# Dekko Knitwear Ltd

Plot # I/5, I/7, I/9, I/11 and I/13, Road # 6, Section-7, Mirpur, Dhaka  
(23.819708, 90.364331)  
16<sup>th</sup> May, 2017

## Observations<sub>4</sub>

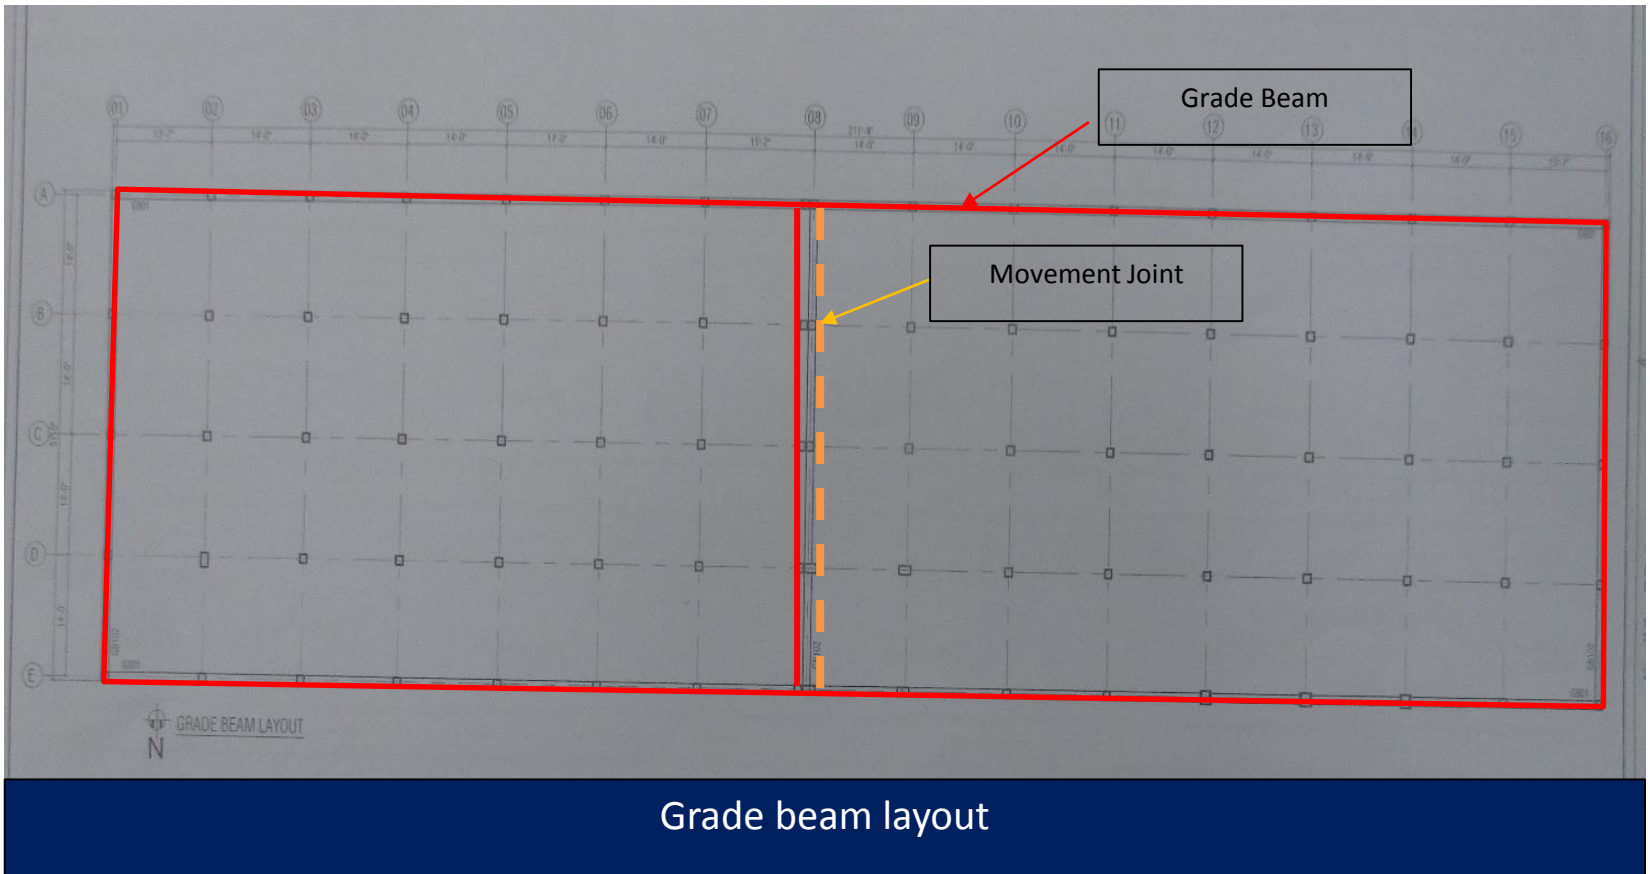
There is no grade beams for internal grids, grade beam exists only in periphery as per provided drawings. Apparently slenderness effect may act on the internal columns. Building engineer is required check the slenderness effect of those columns.

| Item No. | Observation                                      | Recommended Action Plan                                                                                                            | Recommended Timeline |
|----------|--------------------------------------------------|------------------------------------------------------------------------------------------------------------------------------------|----------------------|
| 3        | Check the slenderness effect of internal columns | Building engineer is to check the slenderness effect of internal columns by further reviewing the existing DEA report with Accord. | 6-weeks              |
| 4        | Check the slenderness effect of internal columns | Carryout necessary remedial works where necessary.                                                                                 | 6-months             |
